Savannah River Site

**Explanation of Significant Differences to the
Record of Decision for the
TNX Area Operable Unit**

WSRC-RP-2005-4030

This ESD describes a change to the final remedial action plan described in the *Record of Decision Remedial Alternative Selection for the TNX Area Operable Unit (U)*, WSRC-RP-2003-4017, Revision 1, August 2003, signed on March 25, 2004.

Figure 1. Locations of Proposed Excavations

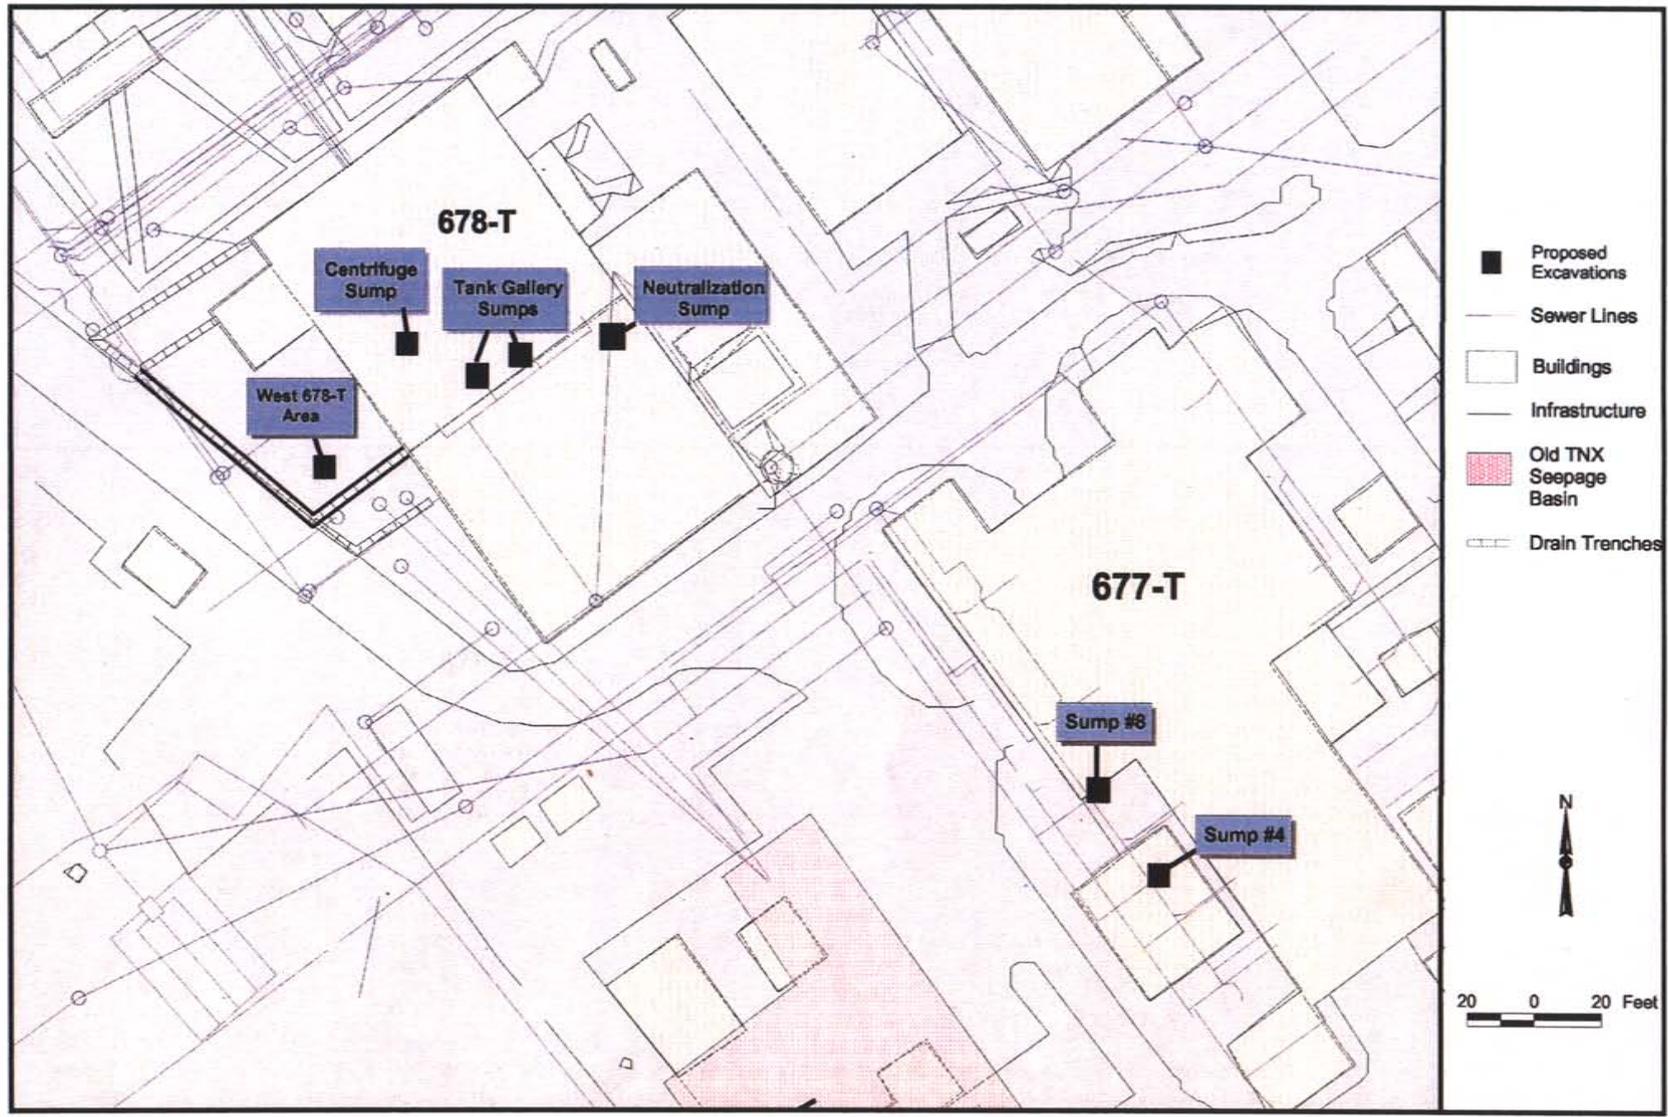
This ESD proposes to modify the selected remedy and the RGs to address the PTSM in the soil within the OTSB/IPSL/DG and associated with selected sumps (neutralization sump, stainless steel sump in the tank gallery, and the centrifuge sump at 678-T, and the #4 and #8 sump at 677-T) and a small area of contamination on the western exterior of 678-T (Figure 1). These changes do not fundamentally alter the previously selected remedy for the OTSB/IPSL/DG and, therefore, a ROD amendment is not required. The changes will, however, affect the volume of material to be excavated for off-site disposal from the OTSB and soil adjacent to the selected sumps at 678-T and 677-T.

- Additional excavation of potential PTSM in soil adjacent to selected sumps (neutralization sump, stainless steel sump in the tank gallery, and the centrifuge sump at 678-T, and the #4 and #8 sump at 677-T) and a small area of contamination on the western exterior of 678-T (Figure 1). The soil adjacent to the sumps will be tested to determine if PTSM due to toxicity is present. The total estimated volume of material that may be impacted is approximately 700 yd³. No PTSM due to contaminant migration has been identified for the OTSB and IPSL. A contaminant migration assessment of the T Area cap provided in the *Remedial Investigation/Focused Feasibility Study/Risk Assessment for the T Area Operable Unit* (WSRC 2005) shows that the proposed cap will reduce the recharge rate to 0.003 inches/year and will be effective in preventing contaminants from migrating to groundwater. Unit-specific soil screening limits for contaminant migration constituents of concern (CMCOCs) under the proposed cap are also higher than toxicity PTSM levels. If CMCOCs are present in the soil adjacent to the
